[HOW TO REPLACE CPU & SOL PCB ASS'Y]

S/N & PART NAME	PART PHOTO
ASTP0PCB001 - MAIN TOP PCB ASS'Y (V1.5.4)	
AZZZ0PCB203 - SOL FET 2CH PCB ASS'Y V2

* UPDATE SUMMARY

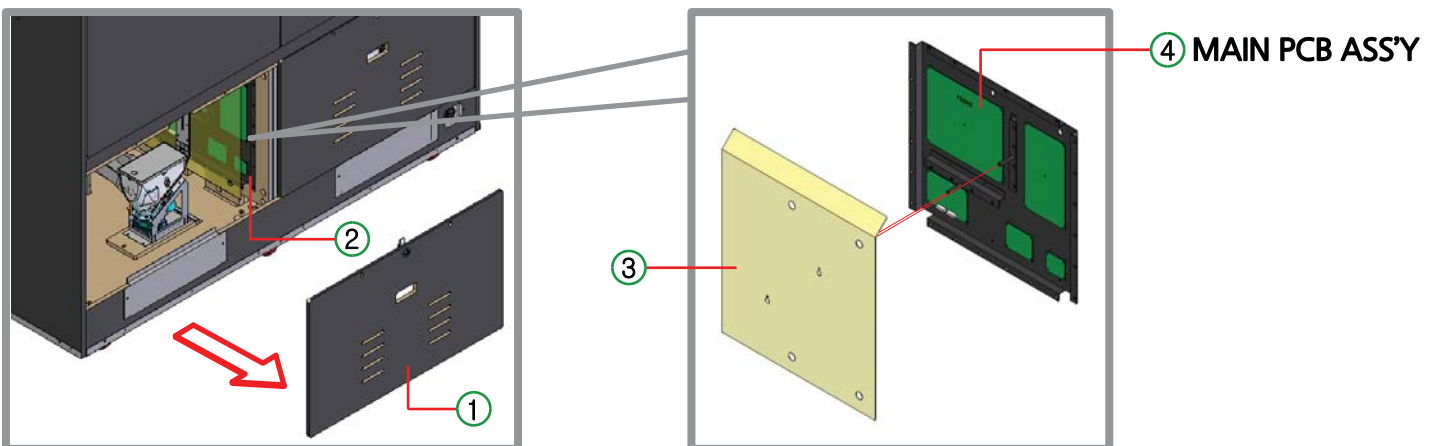
- Solenoid protection against failure or overheating.
- Resolution of a shooting button malfunction during Party Time at Big Wheel Game.
